**C202039**  
**BCA 2019 REPORT**

**2-18 Station Street  
Marrickville NSW**

**Boarding House**

**Revision: 1**

Image: Corridor length more than 40m on levels 1-9.

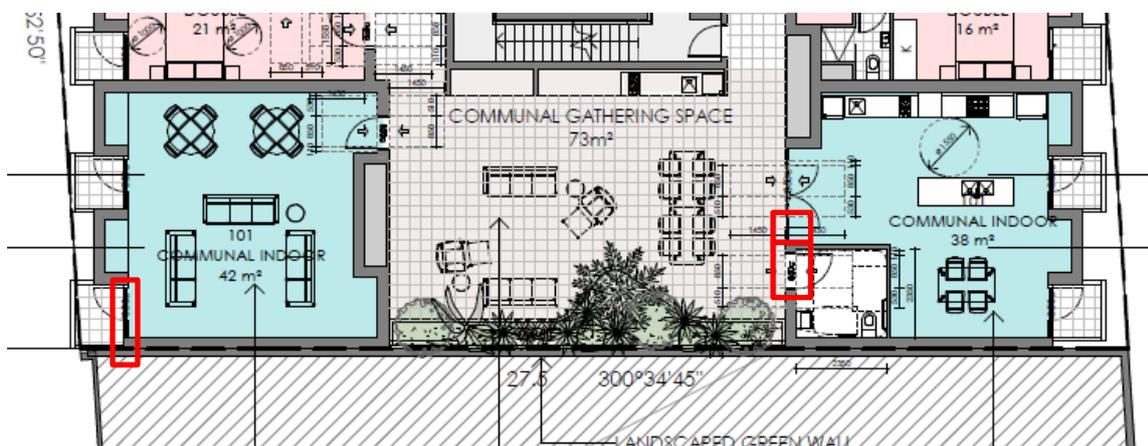
C2.14	Public corridors in Class 2 and Class 3 buildings.	<p>The public corridors on level 1 – 9 appear to be more than 40m in length, excluding the external parts around the void.</p> <p>As such, they must be divided at intervals of not more than 40 m with smoke-proof walls and doors complying with Clause 2 of Specification C2.5, which would be installed perpendicular to the eastern and western side of the lift shafts.</p>  <p>It is noted that a less conservative calculation would result in a public corridor less than 40m.</p> <p>The proponent has indicated that if the public corridors are determined to be more than 40m at construction certificate stage, that they intend to seek a fire engineered performance solution to delete the smoke doors. Any performance solution must also</p>	Subject to fire engineering

take into consideration the potential impact to the ventilation of the public corridors and the stair pressurisation.

Image: Ground floor, four doors requiring compliance with Clause 2 of Specification C2.5.

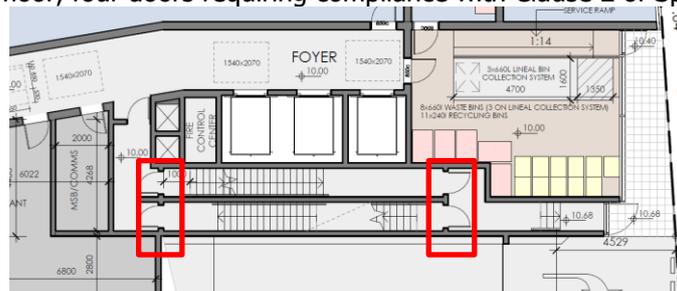
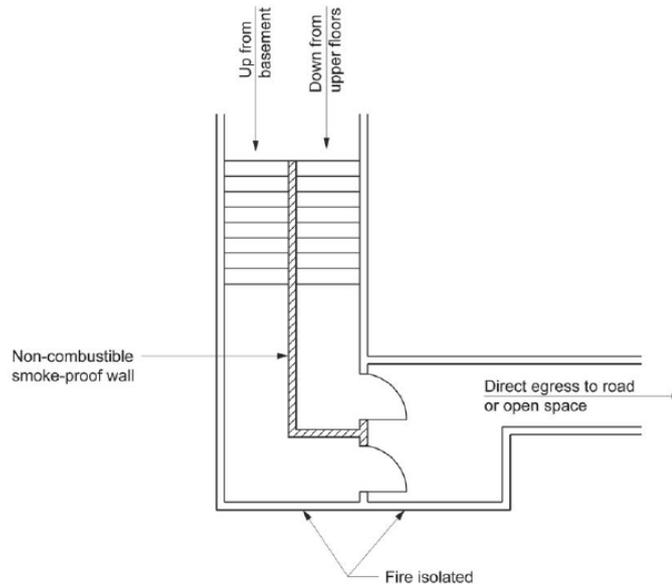
D1.16	Plant rooms and lift machine rooms: Concession.	No plant concession required.	N/A
D1.17	Access to lift pits	The lift pits will be less than 3m in depth and therefore access to the lift pit will be via the lowest landing doors.	Yes
D1.18	Egress from child care centres	No child care centres proposed.	N/A
<b>Part D2</b>	<b>Construction of Exits</b>	<b>Clause Requirements/Comments</b>	<b>Compliance</b>
D2.0	DtS Provisions.	Applicable <i>performance requirements</i> for <i>building solutions</i> .	Note only.
D2.1	Application of part NSW Variation NSW D1.(c).	Part applies.	Note only.
D2.2	Fire-isolated stairways and ramps.	It is assumed that the fire isolated stairs and passageways will be constructed from masonry and concrete, which complies with this clause.	Yes
D2.3	Non-fire-isolated stairways and ramps.	No non fire isolated stairway.	N/A
D2.4	Separation of rising and descending stair flights.	As the fire isolated stairs serving the upper levels and the basement levels are assumed to share one of two shafts, there configuration results in a rising and descending scenario. As such, the discharge doors to the fire isolated passageways at ground level must be non-combustible and smoke proof in accordance with Clause 2 of Specification C2.5.	Design considerations
